Initial Environment Examination

Project Number: 42267-026
December 2018
(Addendum)

IND: Rajasthan Urban Sector Development Program

Subproject : Bulk Water Supply for Pali

Appendix 1: Layout Plan showing Original scope of works as per Detail Design (DPR)

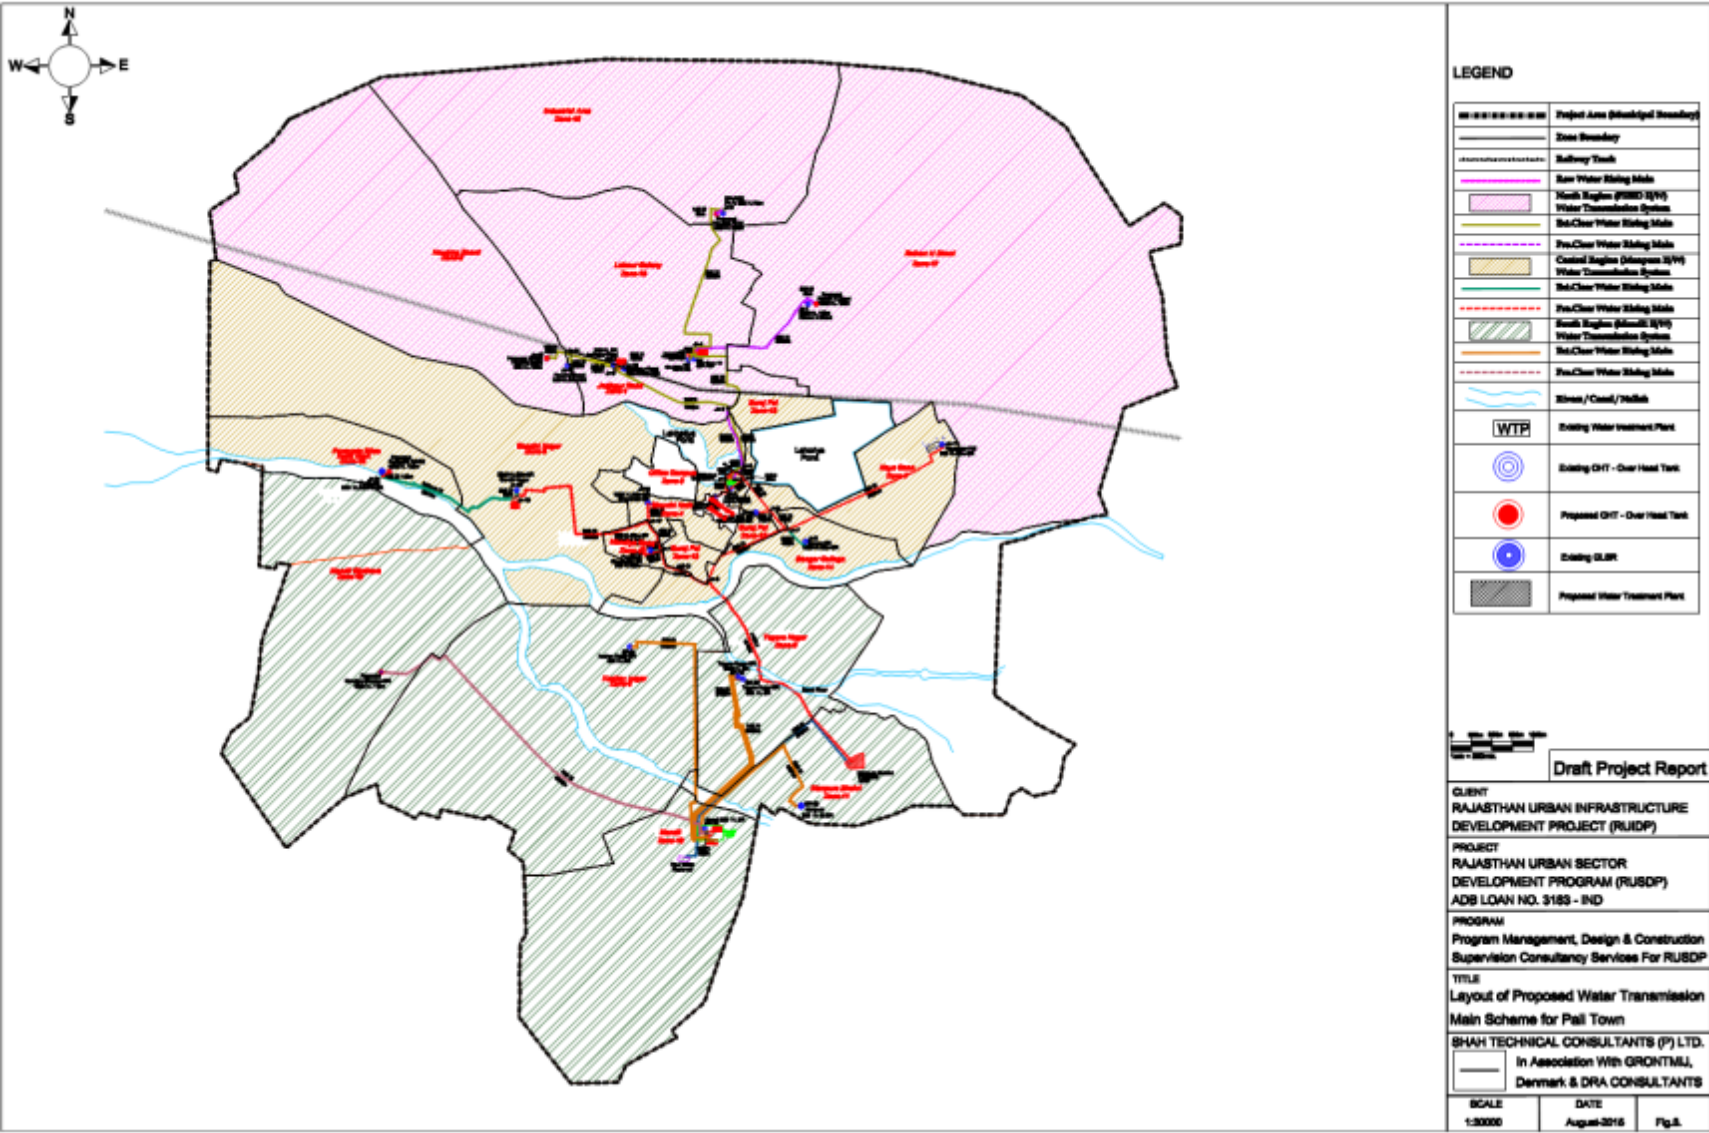
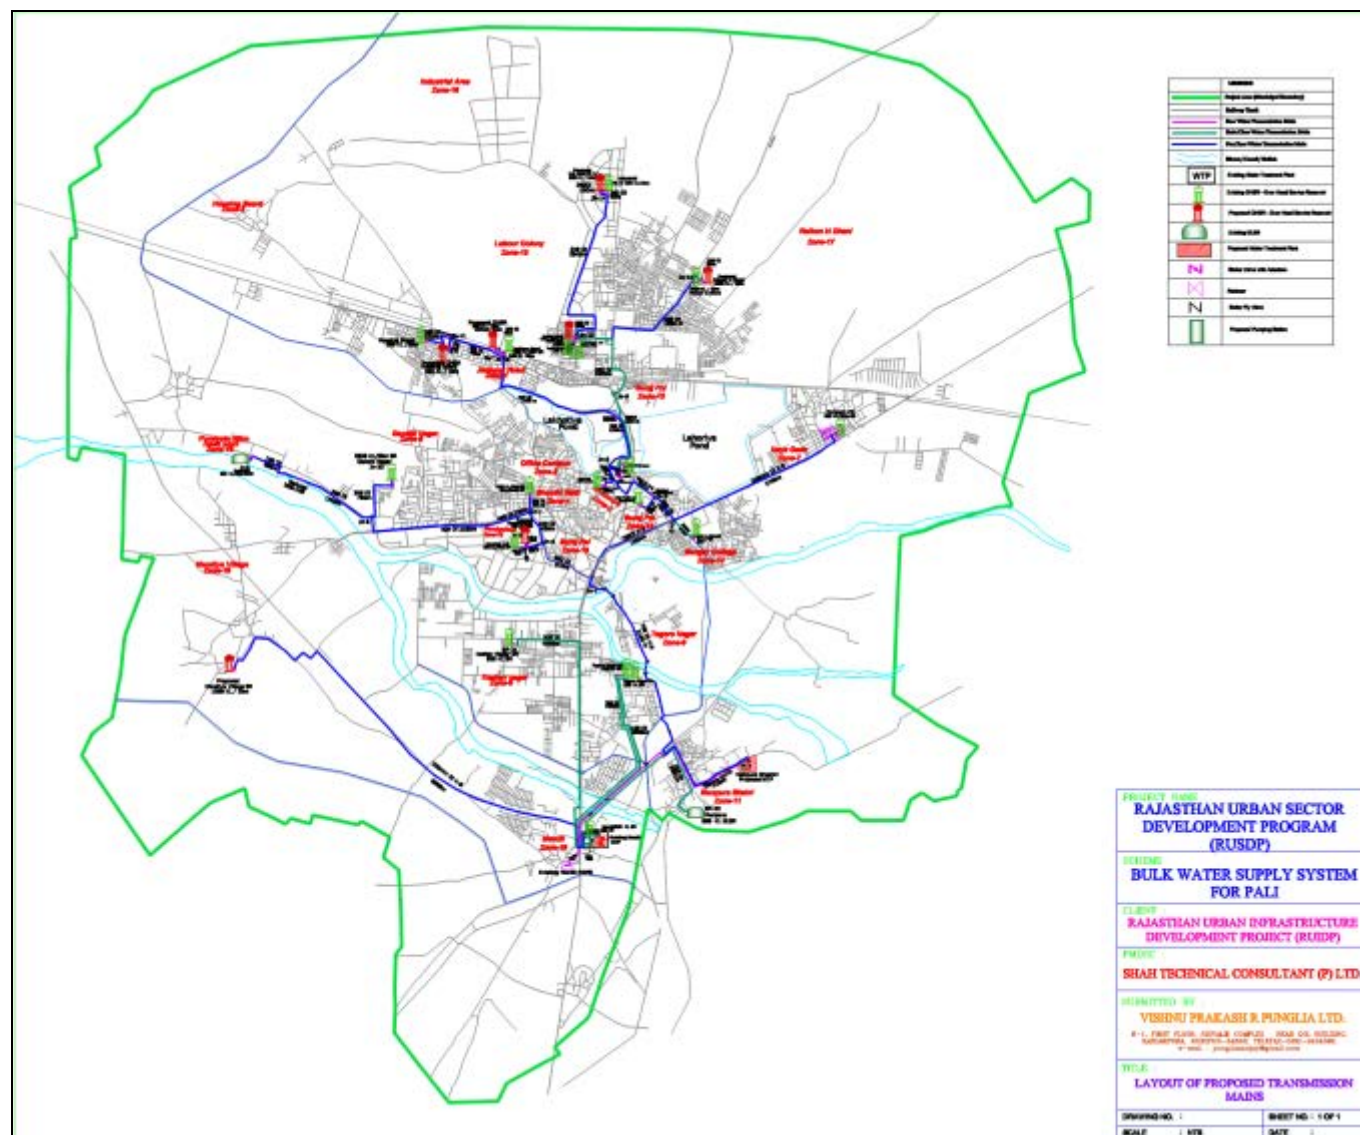
8. The subprojects include laying of water supply pipes in the municipal area of Pali, and construction of a water Treatment Plant (30 MLD at Manpura Bhakhri). Scope of works is updated in only length of pipelines of various diameters in various locations. Layouts of original scope of works, updated scope of works and change in Pipe laying works is given in **Appendix 1-3**. Details of these changes and reason for changes is given in **Table 2** below -

Package-RUSDP/PALI/02						
Detail For Pipeline						
S. No.	Section / Reach	Size (mm)	Length of Pipe (m)		Excess	Reasons of Changes
			As per BOQ	As per SIP		
1	Manpura Bhakhri TO JN-1	700 mm	4248	5165	917	Length increased as NHAI did not permitted for pipe crossing under ROB
2	JN-1 TO JN-2	700 mm		1505	1505	Between Jn-1 to jn-2 Dia 500 to 700 mm Changed in design due to increase demand of Nayagoan i.e. 1.46 to 4.25 MLD
		500 mm	1502			
3	RWPS Mandli To WTP Manpura Bhakri	700 mm	3752	4150	398	Along N H. (DPR route) 7 pipeline are already laid, so changed alignment through Mandli Village
TOTAL			8000	10820	2820	
300 mm						Heavy traffic & underground utilities on Jodhpur road. So, alignment changed along the service road of PHED canal as well as no need of road restoration and dia got changed from original 250 to 300 mm to meet the demand of Jodhpur road and Housing board.
4	JN-3 TO Suraj Pole OHSR	300 mm	208

Appendix 2: Layout Plan Showing updated scope of works as per SIP
